Response Sheet

Organisation: Master Builders Queensland

NCC Volume(s): One Two Three Housing Provisions Livable Housing Design Standard

Figure 6.2a: Location of ~~noggin~~ framing for walls surrounding a bath

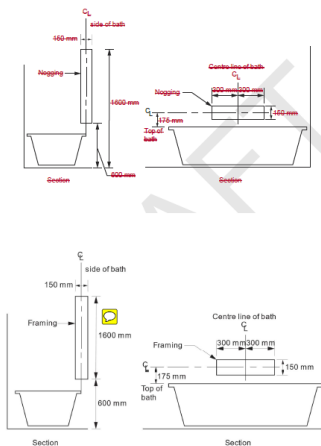
Clause/Figure/Table: Figure 6.2 a

Comment/reason for change:

There is no issue in changing the word noggin to framing.

However, when making those changes within the draft Figure 6.2a they have repositioned the dimensional (1600mm) arrow heads to the top of the framing above the bath. The consequence being that the top of framing is now indicated as being 2200mm above the floor which does provide any benefit or improvement.

It is recommended that Figure 6.2a be amended as follows—

Reinstate the location of the dimensional (1600mm) arrow heads within the draft back to the original location within Figure 6.2a
